Product Change Notification: DSN0-11CVSI654

CCB 7630 Initial Notice: Qualification of ATP7 as an additional assembly site for AT9919K7-GVAO, HV9918K7-G, HV9919BK7-G, AT9919K7-G and HV9967BK7-G catalog part numbers (CPN) available in 8L WDFN (3x3x0.8mm) package.

Pre and Post Change Summary

Lead-Frame Comparison

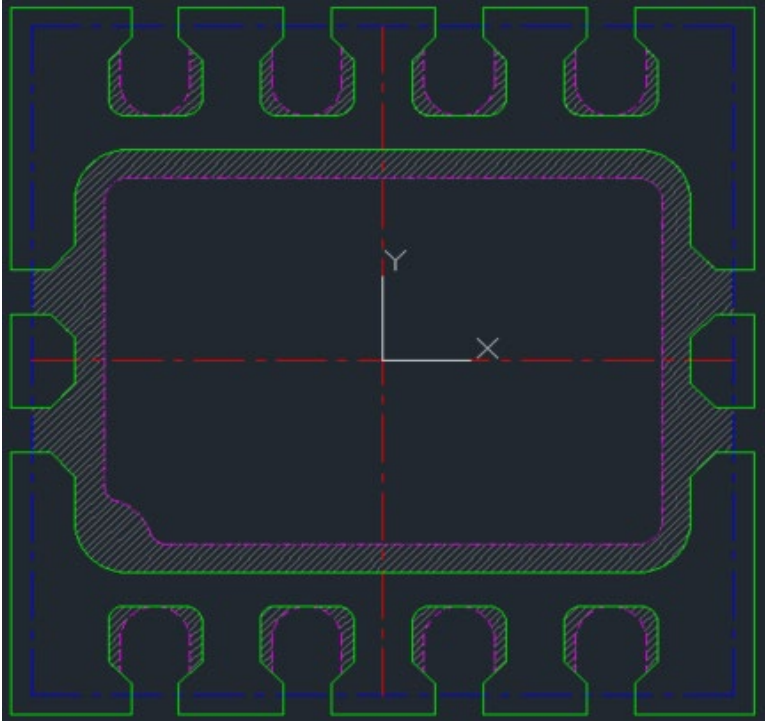
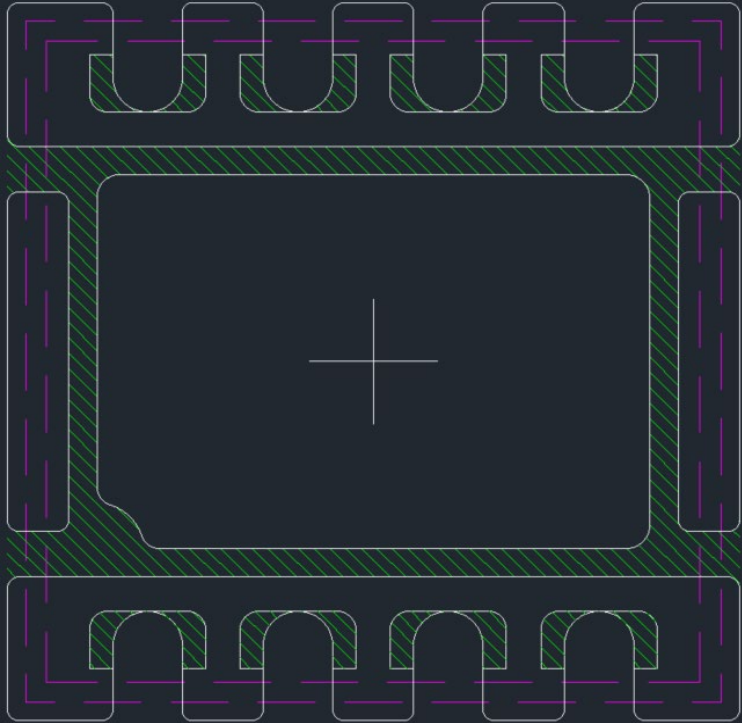
Note: Not-to-scale									
<table><tr><td>Lead-Frame Paddle Size</td><td>104x75 mils</td></tr><tr><td>DAP Surface Prep</td><td>Ag Spot</td></tr></table>	Lead-Frame Paddle Size	104x75 mils	DAP Surface Prep	Ag Spot	<table><tr><td>Lead-Frame Paddle Size</td><td>106x75 mils</td></tr><tr><td>DAP Surface Prep</td><td>Ring Ag</td></tr></table>	Lead-Frame Paddle Size	106x75 mils	DAP Surface Prep	Ring Ag
Lead-Frame Paddle Size	104x75 mils								
DAP Surface Prep	Ag Spot								
Lead-Frame Paddle Size	106x75 mils								
DAP Surface Prep	Ring Ag
